PUBLIC NOTICE
WOODLAND PARK PLANNING COMMISSION
Thursday, July 13, 2023, 6:30 P.M.
Council Chambers – 220 W. South Avenue

- B. **PUD/SPR2023-02 Champion Xpress Carwash PUD Amendment & SPR:** A request by 7B Building & Development (Applicant), represented by Baseline Engineering on behalf of Harman Property Management (Owner), to consider a PUD Amendment to change the use from “Eating/Drinking Place, Eat-in and Drive-through” to also allow a car wash on Lot 4 of the Wal-Mart Center and amend Building and Parking Data. The subject property is located at 19574 E. U.S. Highway 24 with a legal description of Lot 4, Wal-Mart Center, Woodland Park, Colorado and is zoned Planned Unit Development (PUD). (QJ)

Planning Commission Staff Report PC Public Hearing July 13, 2023

SUB2023-04 Pines at Tamarac PUD Master Plan and Preliminary Plat

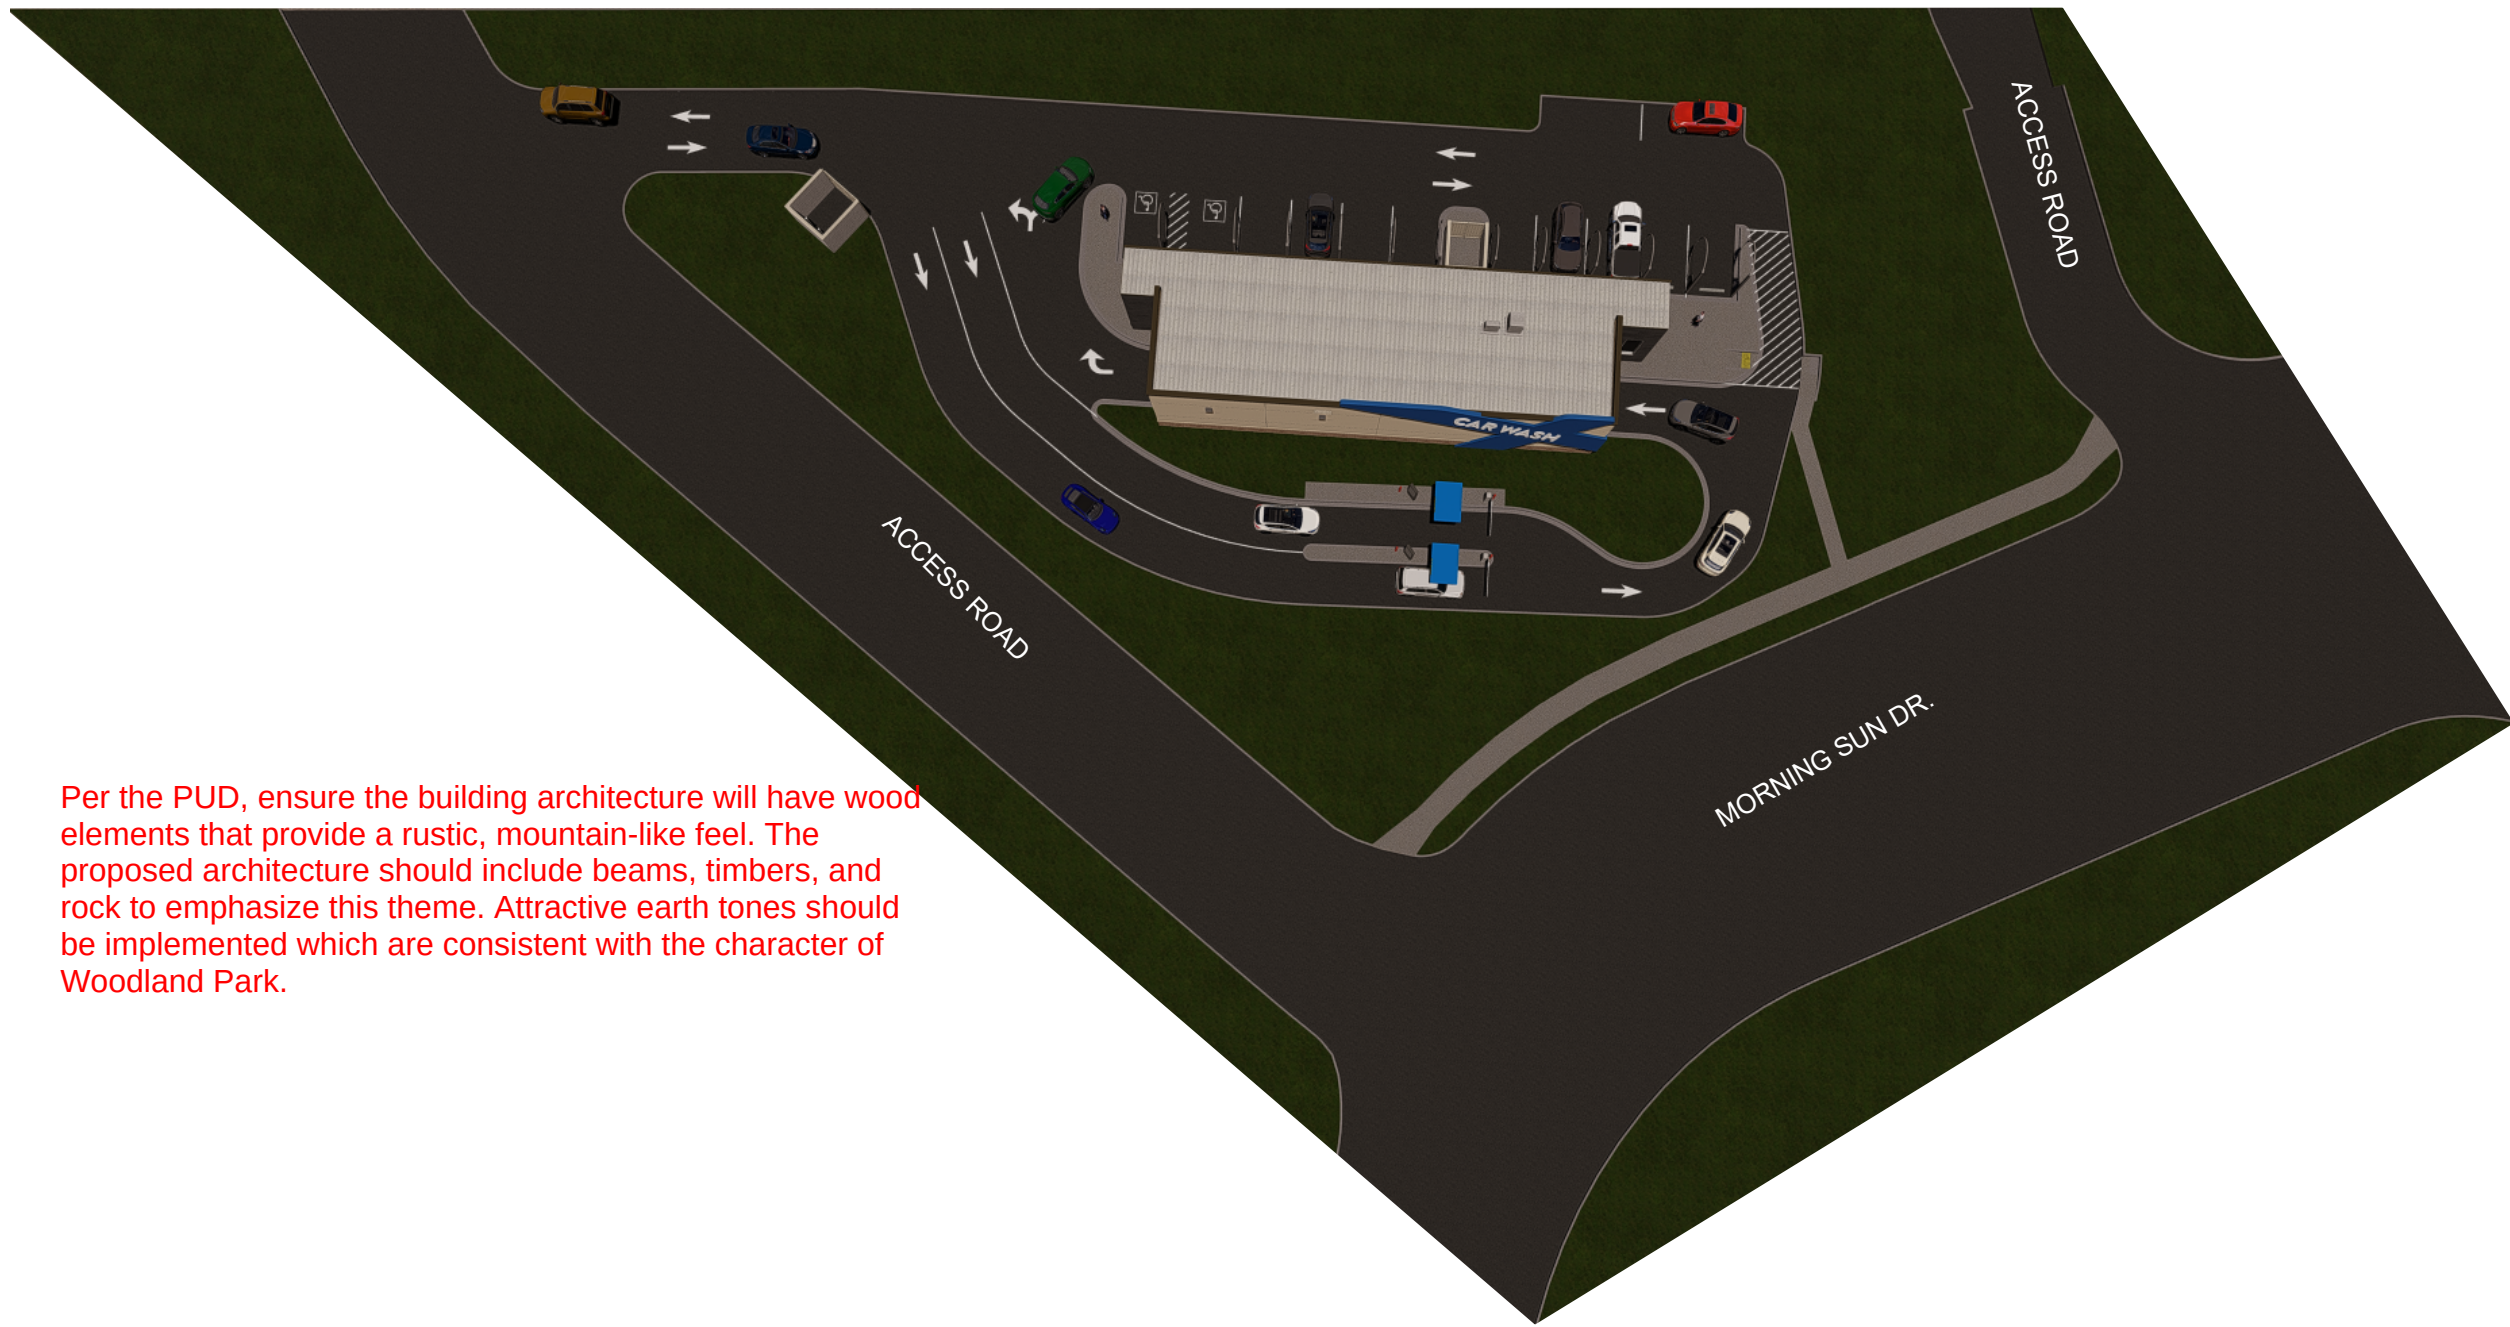
Per the PUD, ensure the building architecture will have wood elements that provide a rustic, mountain-like feel. The proposed architecture should include beams, timbers, and rock to emphasize this theme. Attractive earth tones should be implemented which are consistent with the character of Woodland Park.
